AMENDMENTS TO THE DRAWINGS

Application No. 10/715,069  
Amdt. dated 3/11/08  
Reply to Office action of 12/12/2007

Fig. 1

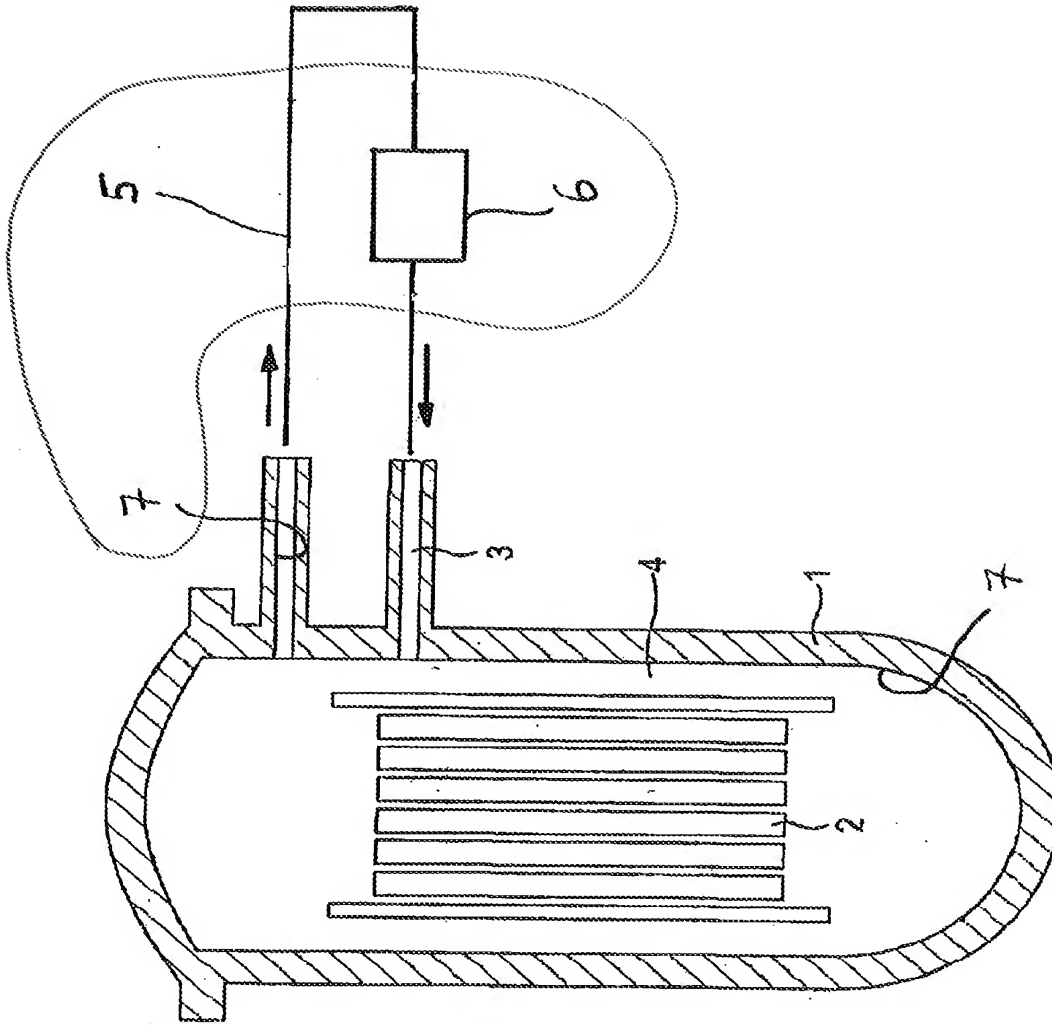
The attached sheet of drawings includes changes to Fig. 1. Specifically, reference numerals 5, 6 and 7 were added. The entry of the amended drawing is respectfully requested.

Item #4 of the current Office Action has objected to the Drawings under 37 CFR § 1.83(a) as failing to show each and every feature of the claimed invention. Applicant submits herewith Replacement Drawing Sheet for Figure 1. Applicant has amended the specification to recite elements set forth in the New Drawing Sheet and has included element 5, a primary system (disclosed, at least, in the specification as filed, at least on page 1, lines 16-22 and page 5, lines 16-22); element 6, a feed water system (disclosed, at least, in the specification as filed, on page 7, lines 24-26); and 7, surfaces of the components (disclosed, at least, in the specification as filed, on page 6, lines 9-10). These elements are disclosed in the specification as noted and due not constitute new matter. Applicant respectfully asserts Replacement Drawing Sheet satisfies the requirements of 37 CFR 1.83(a) and respectfully requests withdrawal of this objection.
